G.O., 12th May 1886, No. 1203 W.

Post Office at Anantapur

Copy of proceedings sanctioning estimate for constructing a — with postmaster's residence, forwarded to the Government of India for approval of certain transfer of funds proposed.

Note of Remarks.

3RD CLASS.

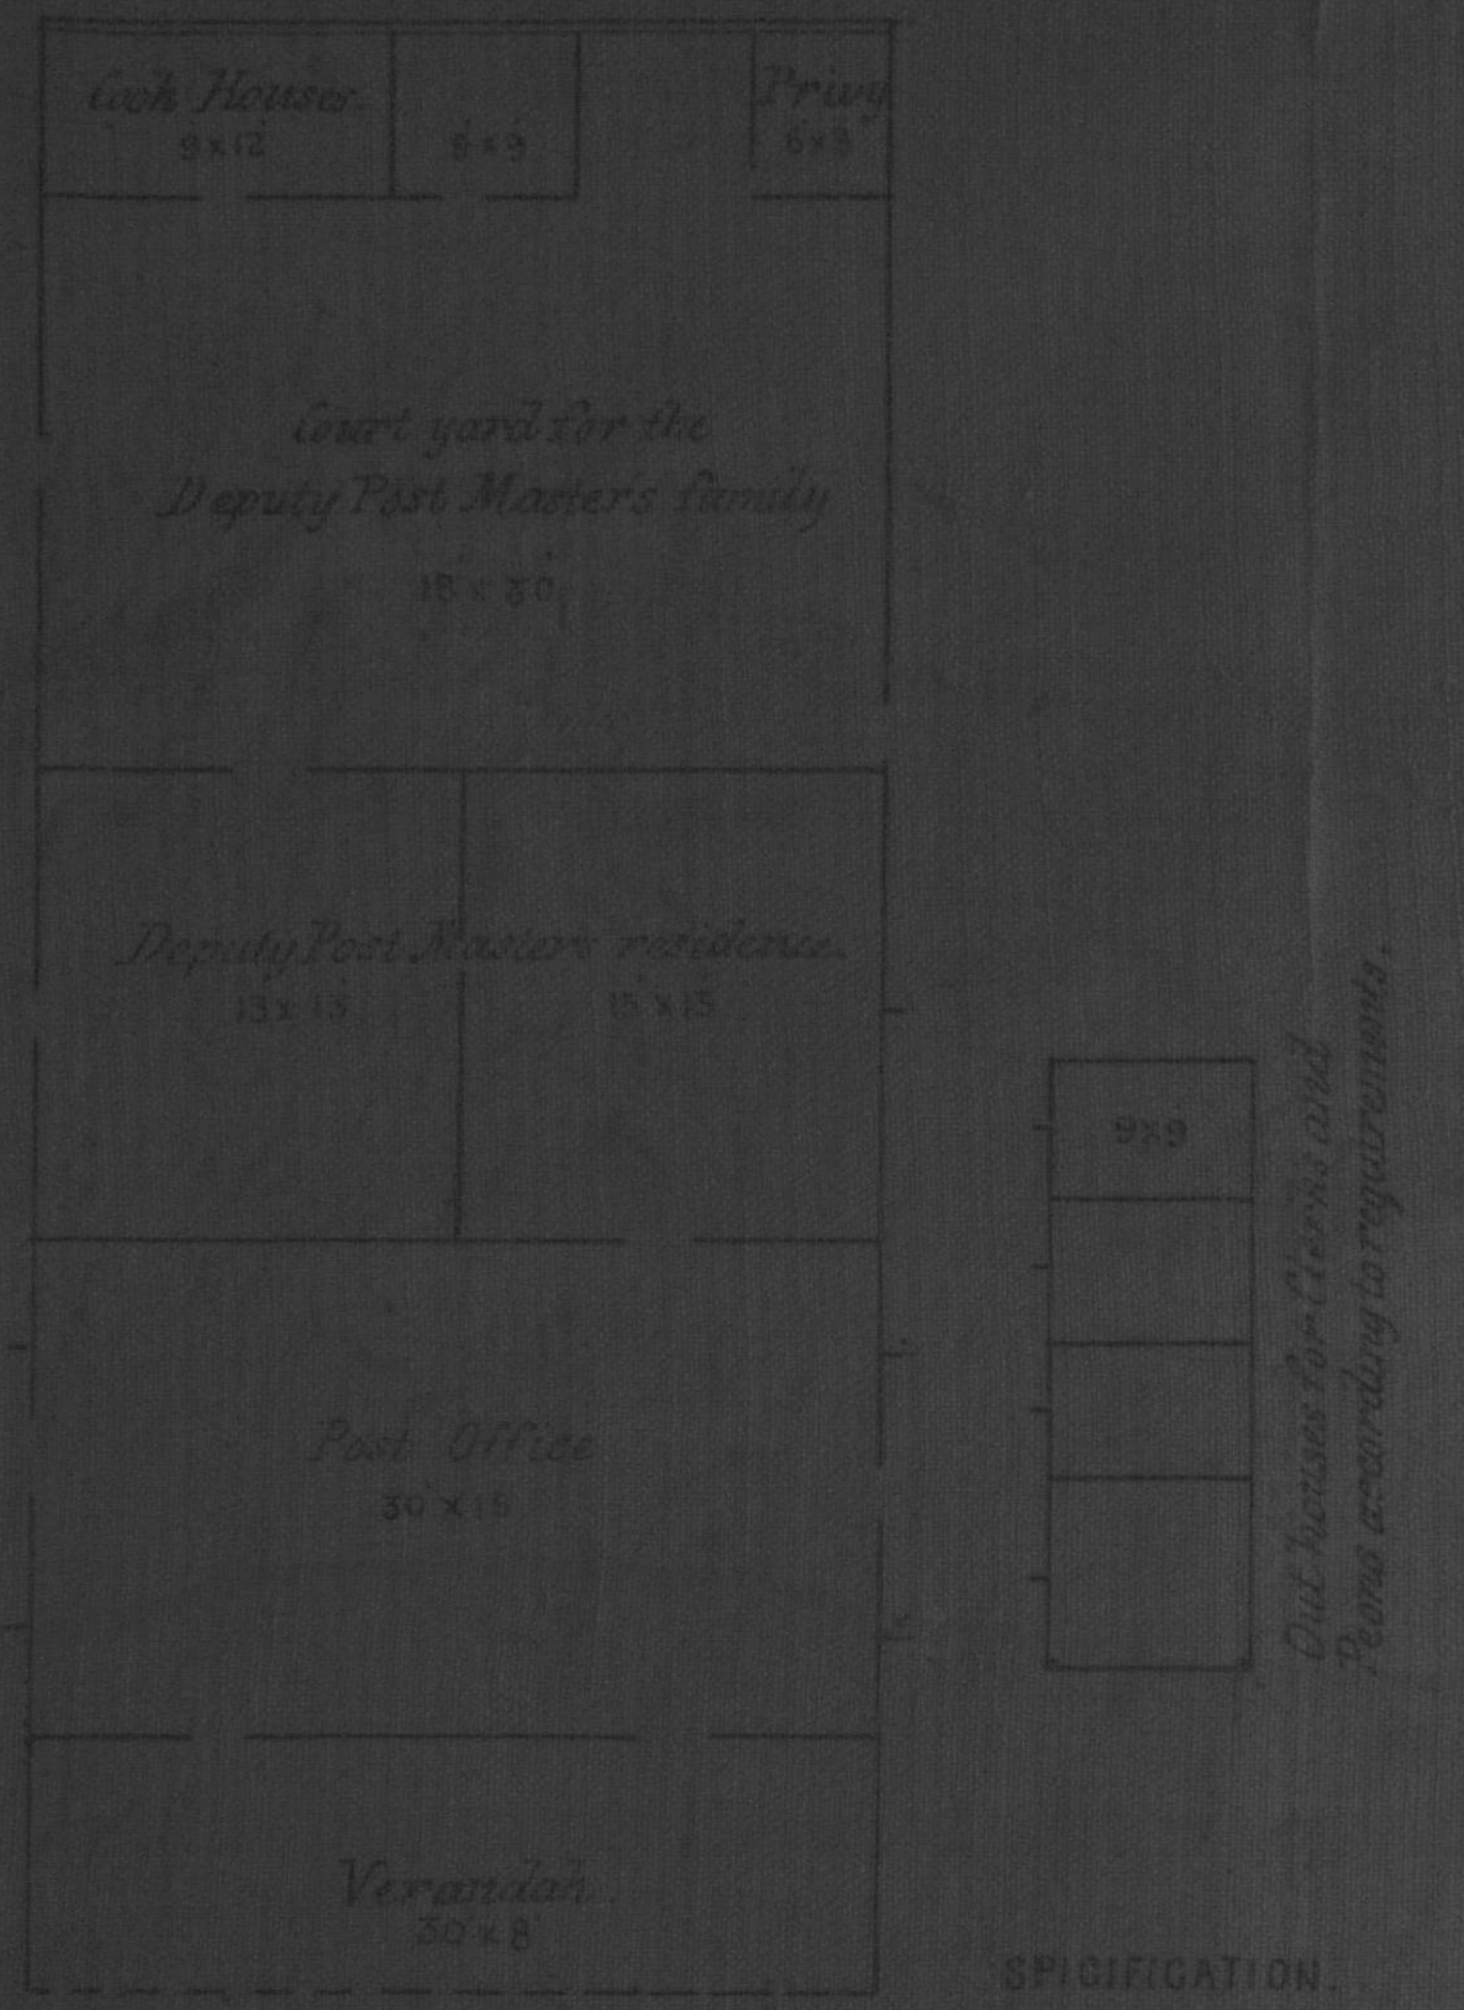
1. The accompanying plan and estimate provide for constructing 3d Class Post office & Post Master's residence with out houses at Anantapur. The estimate amounts to Rs 4051 which is thus divided.

2. The building is to be constructed as per standard block plan, accompaniment to G.O. No 112 of the 14th January 1868.

3. The foundation of the main building

building is to be built of burnt stone in mortar and is to rest on a bed of concrete of broken metal in mortar. The basement & superstructure are to be built of Hammer dressed stone in Chunam.

4. The flooring of the main building is to be of Cuddapah slabs on 3" concrete & the flooring of the out houses is to be gravel, the depth of which is not mentioned in the estimate or specification.

5. The roof of the main building is to be terraced with bricks on edge 3" of small stone concrete + 3 courses of flat tiles and plastered over, and that of the Verandah is Bengal terrace. The roof of the out houses is to be mud consisting of bamboo mats + bamboos, & that of the Privy is to be of bamboo reepers & tiles.

6. The Beams are Moulmein teak, the joists, rafters & bressummers are of Venteak,

7. The scantlings of timbers are correct.

8. The rates are fair.

9. No report has been submitted.

10. The wooden shelves & Counter, the hanging rods & the letter box are to be made according to the plan (to be hereafter supplied) Please see end of specification

Recommended for sanction

The estimate amounting to Rs 4,051, for constructing a 3rd class post office and post master's residence ~~with outhouses~~ at Anantapur is sanctioned.
